Access Compliance Report

Public Rights-of-Way

(Curb Ramps)

Intersection ID: N/A	Main Street: OUTLETS_BV	Cross Street: DESIGNER_DR	Location: SE
ADA ID: 2315987EB2E4	Ramp Type: Perp	Initial Pass/Fail: Fail	Overall Compliance: No
			Severity Score: 21.25

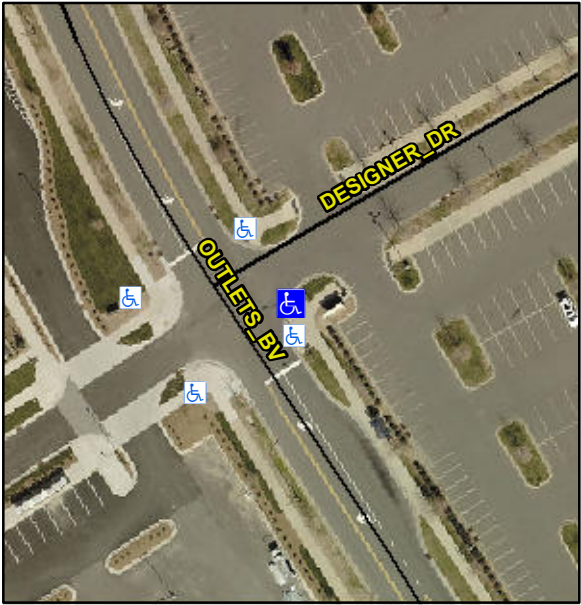
Codes/Mitigation Info/Possible Solution			Field Measurements/Component Compliance		
	Possible Solutions:		Compliance	Description	Data
	Remove & Replace Entire Ramp.		N/A	Ramp Length (in)	94.0
			No	Ramp Width (in)	46.0
			N/A	Flare Type LT	N/A
			N/A	Flare Slope LT (%)	N/A
			N/A	Flare Traversable LT?	N/A
			N/A	Landing Length (in)	N/A
			N/A	Landing Width (in)	N/A
			N/A	Landing Slope (%)	N/A
			N/A	Landing X Slope (%)	N/A
<p>Surveyor Notes:</p> <p>N/A</p> <p>PROW/ADA:</p> <p>R304.5.1, R304.5.3</p>			N/A	Flare Type RT	N/A
			N/A	Flare Slope RT (%)	N/A
			N/A	Flare Traversable RT?	N/A
			N/A	DWS Provided?	N/A
			N/A	DWS Contrast?	N/A
			N/A	DWS Length (in)	N/A
			N/A	DWS Full Width?	N/A
			N/A	DWS Offset (in)	N/A
			N/A	Shared Landing?	N/A
			N/A	Gutter Ponding?	N/A
			N/A	Gutter Lip Ht (in)	N/A
			N/A	Painted X Walk1?	No
				X Walk 1 Direction	To N
			N/A	X Walk 1 Width (in)	N/A
				X Walk 1 Slope (%)	1.9
				X Walk 1 X Slope (%)	1.1

N/A	Ramp inside XWalk1?	N/A
				Road Slope (%)	N/A
				Road X Slope (%)	N/A
			N/A	Any Obstructions?	N/A
				Obstruction Type	
Total Cost:		\$ 1850.00			
			N/A		N/A
			Yes	Surface Condition? (G/P)	Good
